Maule Aircraft Corporation

Service Letter #13

MODELS EFFECTED M-4, M-4C, M-4T, M4S, M-4-210, M-4-210C,
M-4-220C, and M-4-220S

INSTRUCTIONS
FOR
SERVICE LETTER #13

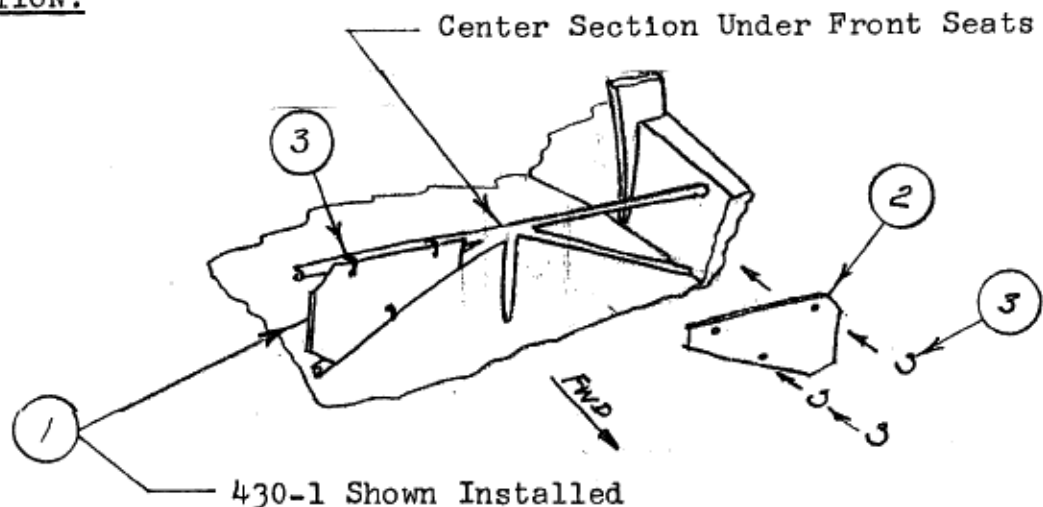
Due to reports of persons unfamiliar with our aircraft confusing the fuel line, which runs across under the front seats, with the seat adjustment handle, there has been one incident in which a passenger pulled on the line by mistake causing a fuel leak in the cockpit. To eliminate this from happening we have designed a plate which when installed on the center section below the seats makes it impossible to get a hold of the fuel line by mistake.

1. Locate Guard Plates 1 and 2 over front of center section tubes as shown (Force to outside for good fit).
 2. Secure in place using 3 Tie Clamps around tubes and thru holes in 1 and 2 plates.
 3. Please fill out enclosed card and return when this installation is made.
- * If the fuel line projects forward of the center section making contact with the Guard Plate when installed, the fuel line will have to be rerouted rearward as shown on page 2 of these instructions.

VIEWED FROM TOP

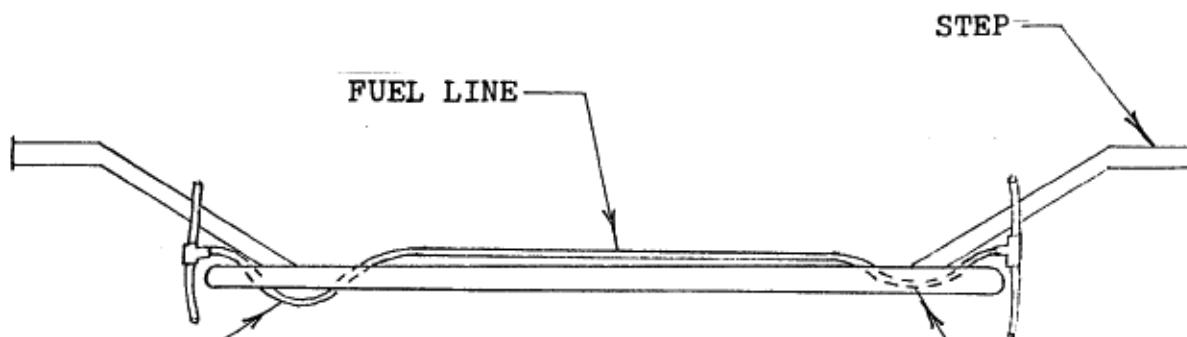
IF YOUR FUEL LINE PROJECTES FORWARD OF TUBE SECTION AS SHOWN HERE. REROUTE FOR CLEARANCE BETWEEN FUEL LINE AND GUARD PLATE AS SHOWN HERE

VIEW LOOKING AFT

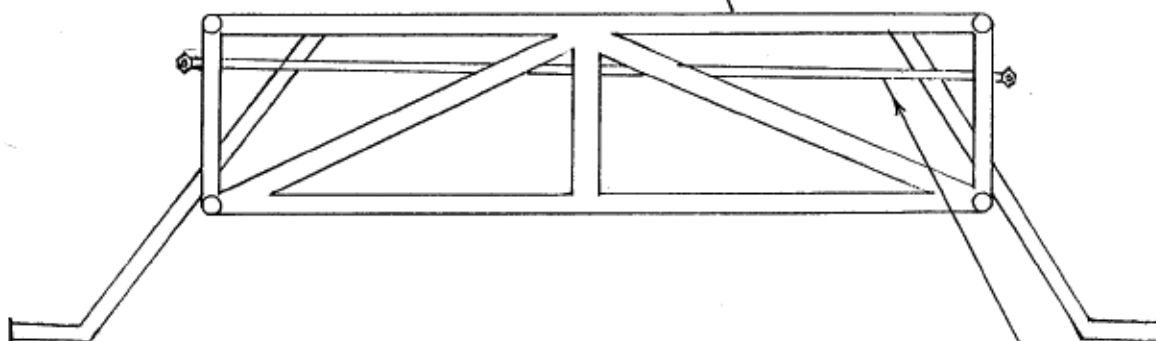
ROUT FUEL LINE KEEPING IT LEVEL WITH NO LOW SPOTS.
